STATE OF WASHINGTON
DEPARTMENT OF ECOLOGY

MEMORANDUM

SUBJECT: Failure Assessment of French Slough Impoundment; SN07-0651

This memorandum summarizes opinions and judgments of the DSO as to the cause of the April 2010 failure of the 30-million gallon Waste Storage Pond operated by the Bartelheimers near Snohomish, Washington.

Figure 3

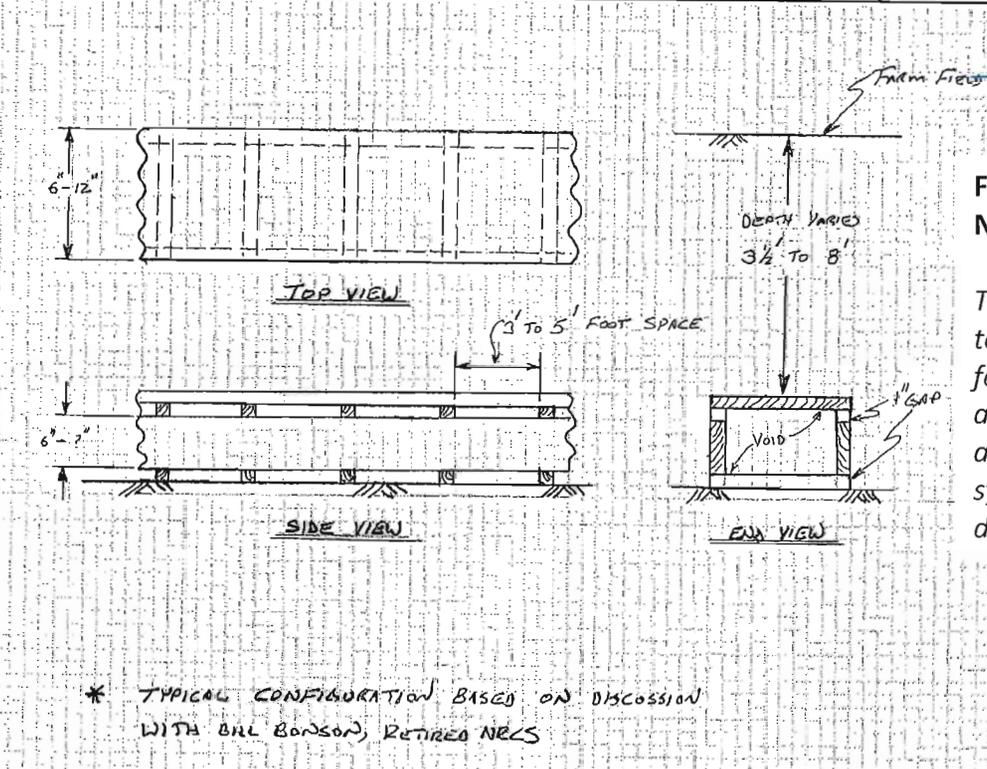
Figure 3 shows a conceptual view of typical design practice for field drains in the 1930s and 40s provided to the DSO by the NRCS. The photo insert in the corner of Figure 3 shows a short exposure of the cedar drain in one of the April 21st test pits dug to investigate the failure. There are notable differences between the conceptual view of such field drains and what was done at the Bartelheimer site. Those differences include elimination of the 1” wide gap between both the lid and sideboards and the sideboards and earthen floor of the drain section. Presumably, such gaps were provided to allow seepage to enter the drain from the top and bottom. At the Bartelheimer site the drain relied principally on seepage entering the unlined floor of the drain via lengthy sections where the bottom of the drain rested on relatively pervious silty sand. Narrow gaps between the individual boards forming the lid and between successive planks of the drain sidewalls provided some limited additional inlet capacity for seepage to enter the drain directly out of the fine grained soil mantle.

Figure 4

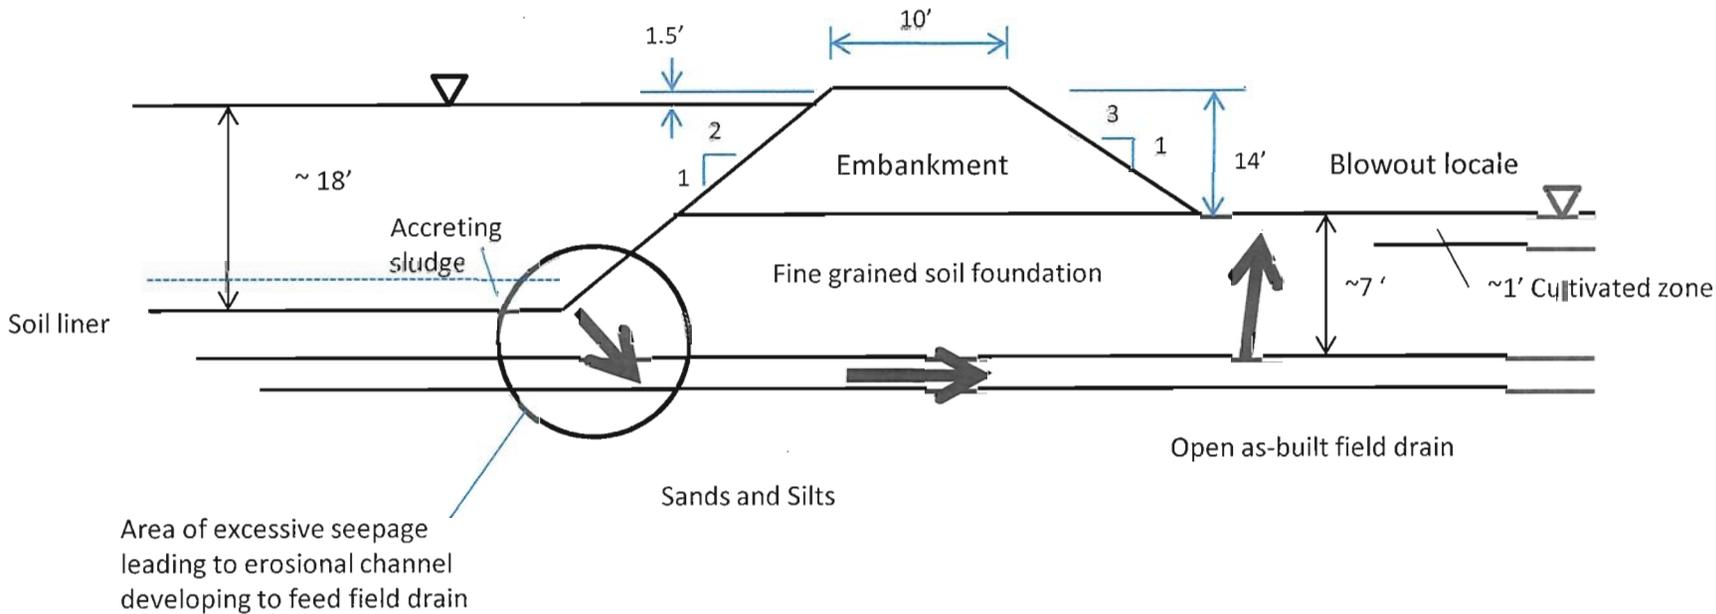
A seepage induced failure requires two things: 1) a continuous pathway for seeping fluid to escape the pond and 2) a flow quantity down that pathway sufficient to wash away soils faster than the pathway can heal⁷ itself. In this case there are three separate reaches to this continuous pathway: the short reach between the pond bottom and the field drain, the field drain beneath the embankment, and the upward pathway through the soil layer to reach the ground surface. (See Figure 4.)

Figure A1

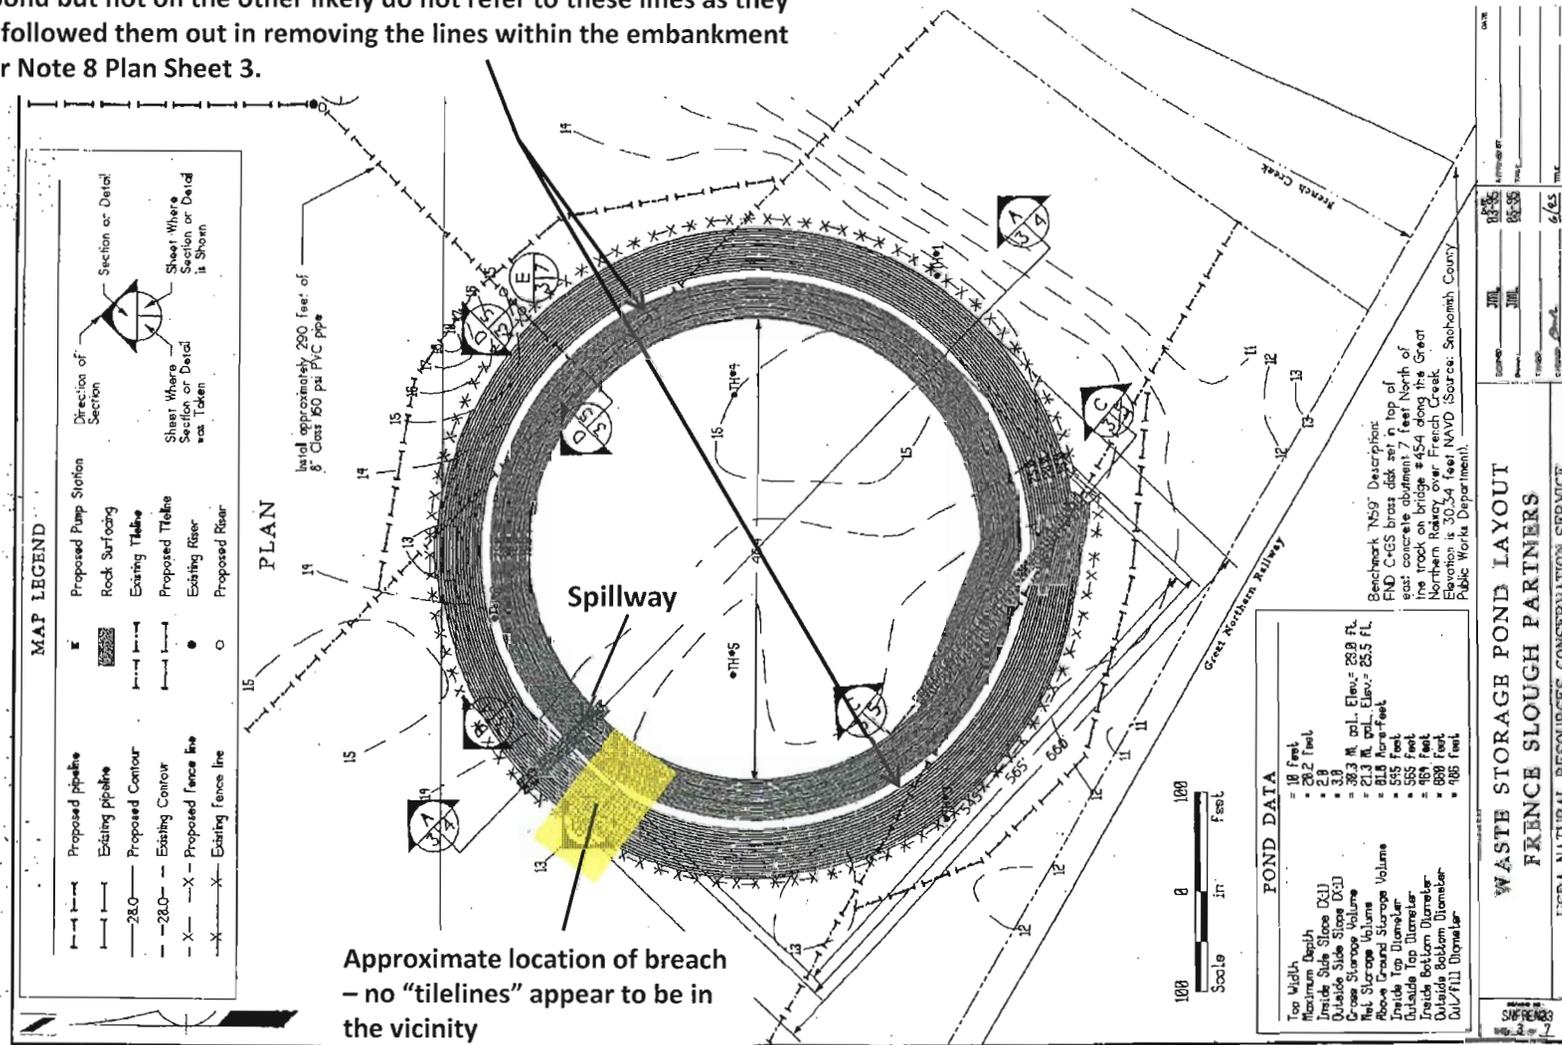
- 3) Plan Sheets 2 & 3 (see Figure A1 of Appendix A) show existing "tilelines" that passed through the dike footprint in the northeast and southwest arcs of the circular embankment (well away from the breach area). Note 8, Plan Sheet 2 (see Appendix B) stated, "Any existing tilelines extending into the proposed pond area shall be removed at least 25 feet outside of the proposed pond area".

- 7) The breach occurred a few tens of feet counter-clockwise from the Spillway, see attachment French Creek Plan Sheet 3. This Plan Sheet shows no buried "tilelines" running anywhere near the breach site, see Figure A1.

The plans call for removal and rerouting of the "tilelines" around the impoundment. The comments LaVassar heard about finding the drains on one side of the pond but not on the other likely do not refer to these lines as they would have followed them out in removing the lines within the embankment footprint per Note 8 Plan Sheet 3.

Figure A5

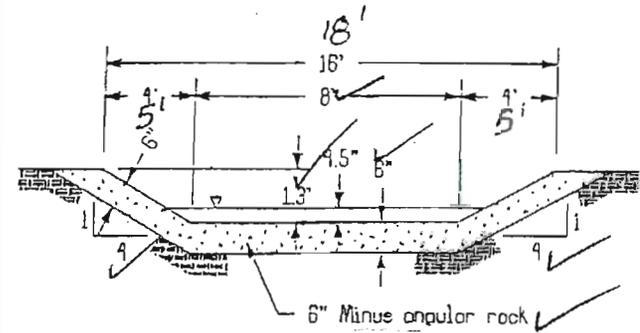
The high effluent level in the pond appeared to have exceeded the invert elevation of the emergency spillway in the not too distant past. This opinion was based on the solids deposited out of the flow as much as some 2 inches above the invert elevation of the spillway at the control section, see Figure A5. Assuming the plan details were accurate, the distance between the control section of the spillway and the crest was some 15 to 16 inches. Accordingly, visual evidence indicates the maximum pool level was probably within 12 inches of the dike crest here. Locally, the crest showed evidence of having had shallow surface flow across its surface at a few spots typically on the north to northeasterly section. It was our opinion that this flow represented wind driven waves splashing up on to local, slightly depressed reaches of the crest. A visual inspection of the high pool mark around the pond was consistent with such an elevated pool. Further, while complicated by the presence of grasses and the remnants of vines, it appeared the dike crest elevation was relatively uniform. That could reflect minimal settlement since

Figure A9

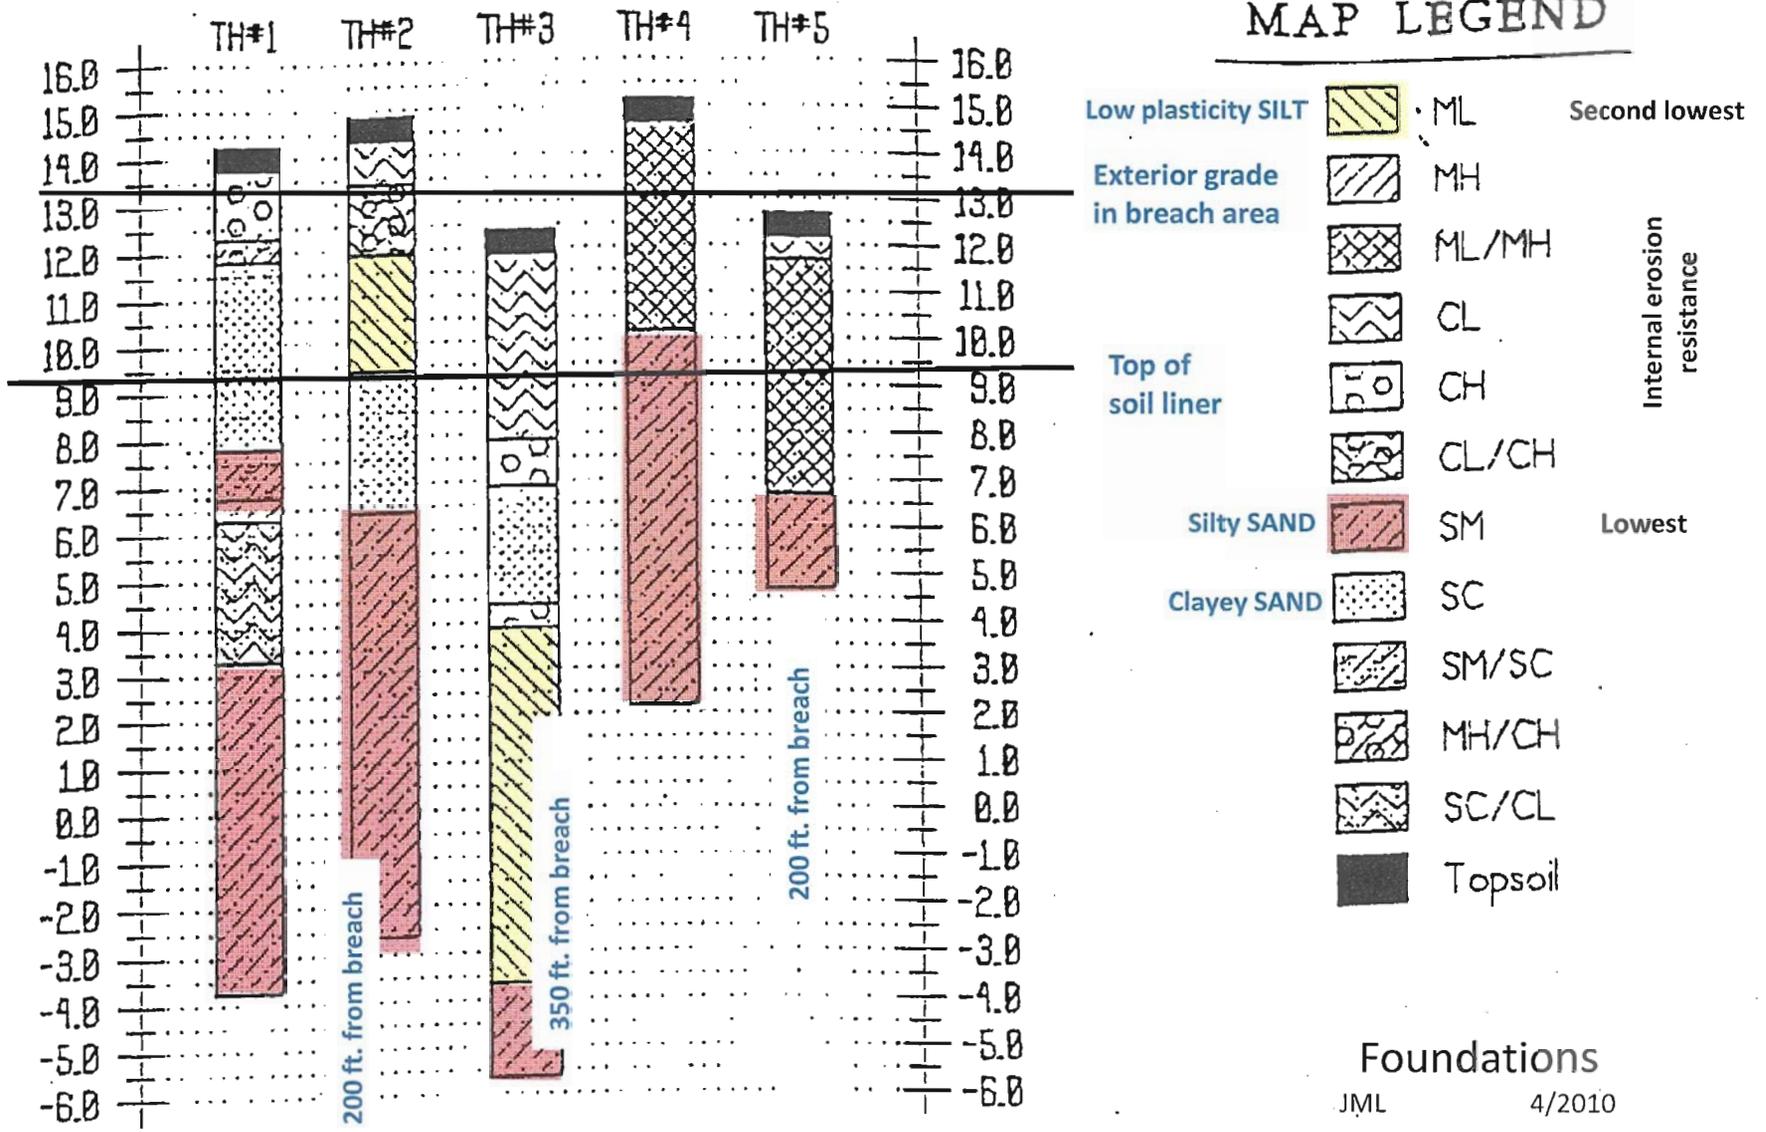
This lumber was partly embedded within relatively uniform, clean fine sand, Figure A2. Visually, that sand was starkly different from the soils (clay and silt) and muck of the majority of the breach. All five of the Test Pits, Figure A9, excavated in developing the impoundment plans

encountered silty SAND (SM) at depths variously a foot or two above the elevation of the base of the pond to depths typically less than 4 ft below the pond base. The surface of the silty SAND equates to a minimum depth of 3 feet to a more typical 7 foot depth below field grade, Figure A10. Jason Bartelheimer related a story his father told him of being 8 and seeing mounds of sand produced in excavating for the underdrains back in the 1940s. Jason's father reportedly described the sands as seeming to sparkle in the sun which had prompted him to ask if there might be gold in the piles. Aside from the sand exposed in the debris field, we observed no surface exposures of such sands. The observed lumber and associated sand again suggest the possibility that a blow out of the impoundment occurred with at least a portion of its length down the wooden underdrain system that dates back to the 1940s. Conversely, we could not come up with a plausible alternative explanation that would account for the observed sound, wet, aging lumber's presence in the debris field.

Figure A10

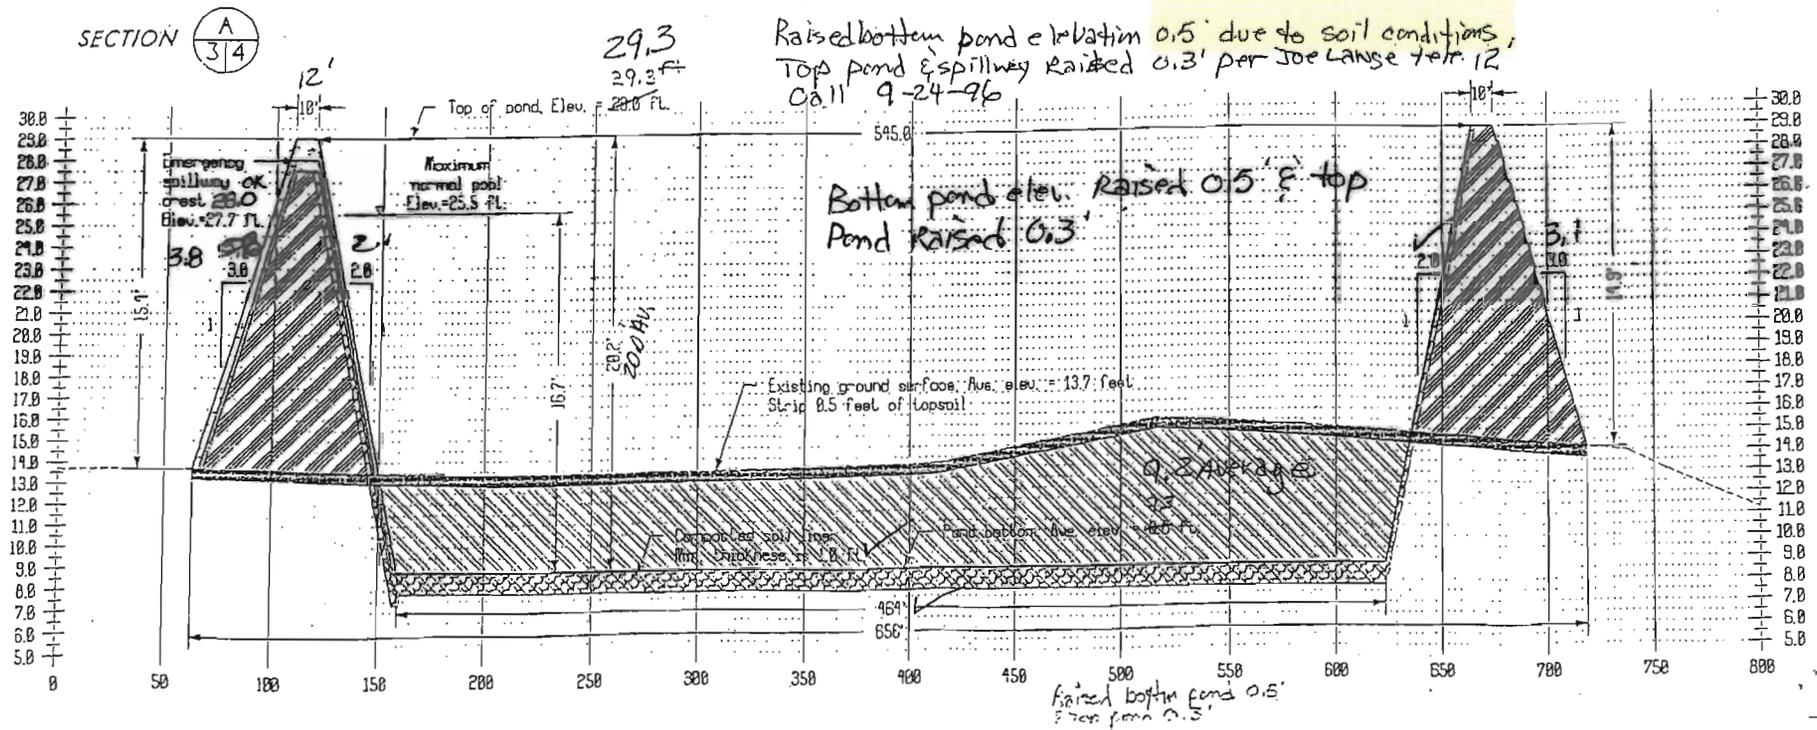
- 1) A hand written note states the pond bottom was raised "0.5' due to soil conditions". Ideally, the construction record identifies what soil conditions prompted that change.
- 2) The compacted soil liner is shown extending up the 2H on 1V interior pond sideslopes. Compacting this facing zone would have been a challenge. We can come up with schemes to do it, but they involve variously overbuilding the zone, bringing it up coincidentally with the adjacent section of the fill, yo-yoing a roller up the slope, or using a compactive plate hung off a backhoe boom. Again, ideally the construction records describe what was actually done.
